Access Compliance Report

Public Rights-of-Way

(Curb Ramps)

Intersection ID: 13786	Main Street: E_7TH_ST	Cross Street: LAMAR_AV	Location: W
ADA ID: 8D890CEFF446	Ramp Type: Perp	Initial Pass/Fail: Fail	Overall Compliance: No
Severity Score: 10			
Codes/Mitigation Info/Possible Solution		Field Measurements/Component Compliance

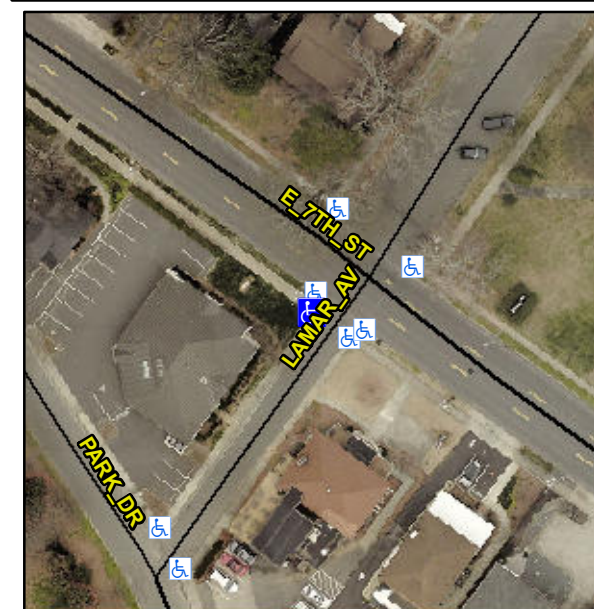
Not Found, R304.5.1, R304.5.3

Compliance	Description	Data	Compliance	Description	Data
N/A	Ramp Length (in)	25.0	Yes	Ramp Slope (%)	4.3
No	Ramp Width (in)	47.0	No	Ramp XSlope (%)	3.6
N/A	Flare Type LT	N/A	N/A	Flare Type RT	N/A
N/A	Flare Slope LT (%)	N/A	N/A	Flare Slope RT (%)	N/A
N/A	Flare Traversable LT?	N/A	N/A	Flare Traversable RT?	N/A
N/A	Landing Length (in)	N/A	N/A	DWS Provided?	N/A
N/A	Landing Width (in)	N/A	N/A	DWS Contrast?	N/A
N/A	Landing Slope (%)	N/A	N/A	DWS Length (in)	N/A
N/A	Landing X Slope (%)	N/A	N/A	DWS Full Width?	N/A
N/A	Landing Curb? (Y/N)	N/A	N/A	DWS Offset (in)	N/A
N/A	Shared Landing?	N/A			
N/A	Gutter Ponding?	N/A	N/A	Gutter Slope (%)	N/A
N/A	Gutter Lip Ht (in)	0.5	N/A	Gutter X Slope (%)	N/A
N/A	Painted X Walk1?	No	N/A	Painted X Walk2?	N/A
	X Walk 1 Direction	To SE		X Walk 2 Direction	N/A
N/A	X Walk 1 Width (in)	N/A	N/A	X Walk 2 Width (in)	N/A
	X Walk 1 Slope (%)	4.3		X Walk 2 Slope (%)	N/A
	X Walk 1 X Slope (%)	1.0		X Walk 2 X Slope (%)	N/A

Remove & Replace Entire Ramp.
